**ICC Docket No. 08-0532**

**Commonwealth Edison Company's Response to  
IIEC Data Requests 2.01 – 2.07  
Dated: March 3, 2009**

**The data requests below relate to the Testimony of Mr. Alongi (ComEd Ex 1.0) pages 14-22 relating to the primary/secondary split.**

**Commonwealth Edison Company's Response to  
Illinois Commerce Commission ("STAFF") Data Requests  
PL 3.01 – 3.17  
Dated: April 6, 2009**

Figure 1 – Transformer Serving Secondary Distribution System

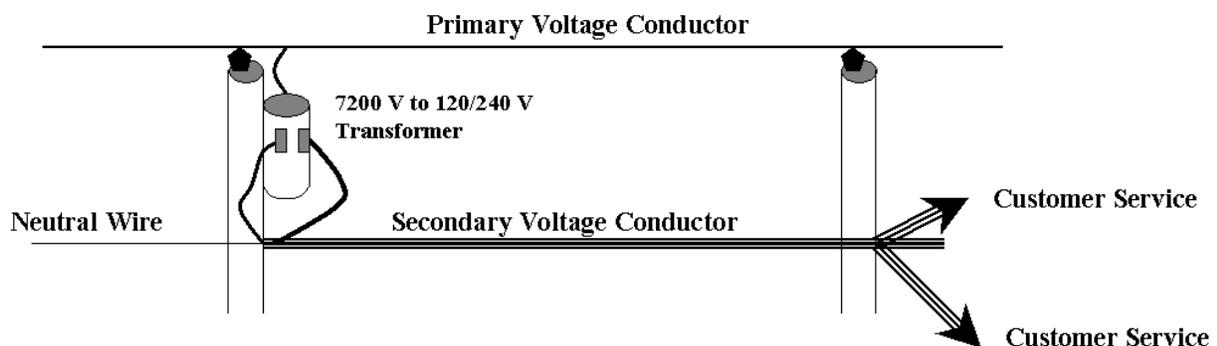
**REQUEST NO. PL 3.16:**

- a. Has the Company sought to estimate the share of transformers (and associated costs) that are dedicated exclusively to customers receiving secondary service?
- b. If the answer to part a. is no, would it be possible for the Company to provide such an estimate?

Figure 1 displays a single-phase overhead transformer that is connected to a secondary distribution system, which is connected to two customers' electric service entrance equipment via that secondary distribution system in conjunction with service connections from that secondary distribution system to the individual customers' electric service entrance equipment. Figure 2, displays a similar transformer that is directly connected to one individual customer's electric service entrance equipment via only a service connection. Figure 3 displays a transformer that is connected to two customers' electric service entrance equipment via that secondary distribution system in conjunction with service connections from that secondary distribution system to the individual customers' electric service entrance equipment and is also directly connected to one individual customer's electric service entrance equipment via only a service connection. Figure 3 is a combination of the basic configurations shown in Figure 1 and Figure 2.

If ComEd were to consider certain transformers to be a part of ComEd's secondary distribution system rather than ComEd's primary distribution system, only the transformer in Figure 1 would be included in its entirety as secondary. The transformer in Figure 2 would continue to be included as primary and would need to be assigned to customers that are not served from transformers like those in Figure 1. Additionally, the transformer in Figure 3 would need to be allocated proportionally to primary versus secondary based on a designated parameter such as customer loads (e.g., the loads of customers connected directly to the transformer via a service connection versus the loads of customers connected to the transformer via the secondary distribution system) or by count of customers (e.g., the number of customers connected directly to the transformer via a service connection versus the number of customers connected to the transformer via the secondary distribution system). Such distinctions would add unnecessary complexity to the assignment of costs to secondary versus primary. Currently in ComEd's Primary/Secondary analysis and the resulting ECOSS, primary costs are properly assigned to all non-high voltage customer service points including those that take service from ComEd's secondary distribution system.
